Nine Mile Point Nuclear Station

SUBJECT: Nine Mile Point Unit 1
Docket No. 50-220
License No. DPR-63

Response to NRC Staff Preliminary Questions Regarding Structural Flaw
Evaluation Methodology Provided via Email dated April 8, 2004 (TAC
MC0930)

Subject: Discussion of Effect of Cladding-Induced Stresses on Evaluation of Nine Mile Unit 1
Closure Head Flaw Evaluation

Figure 1. Typical Stress Distribution in a Clad Plate [from Reference 4]

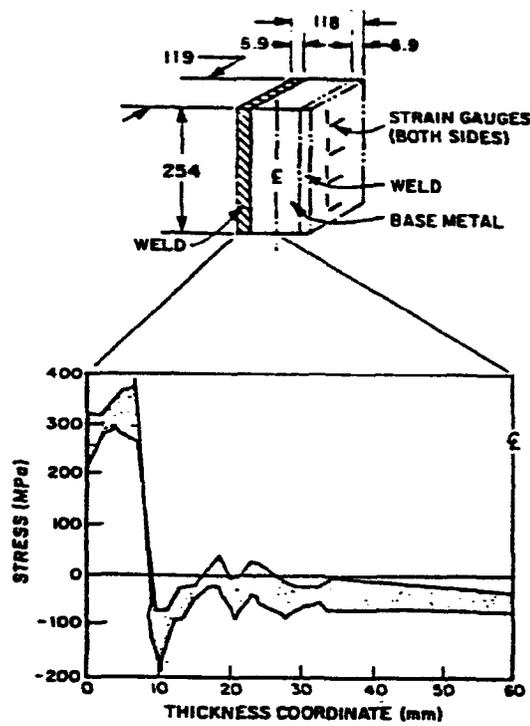
There is a large body of data on the residual stresses in welded clad plate as a result of the application of stainless steel cladding. References 4 and 5 are typical. Figure 1 (from Reference 4) shows the envelope of the residual stresses due to cladding in plate material with a thickness comparable to the NMP top head. This figure demonstrates the discussion in both References 4 and 5 and shows that the room temperature stresses in the cladding are tensile, while the stresses in the base metal are very near zero or compressive. For the NMP flaw that extended from about 10.6 mm to 18.2 mm from the clad ID surface, this figure would indicate that the cladding induced stresses would be compressive at the point nearest the clad-to-base metal interface, and either near zero or compressive at the point nearest the center of the plate. Other figures in References 4 and 5 show that stresses in the entire region are compressive.
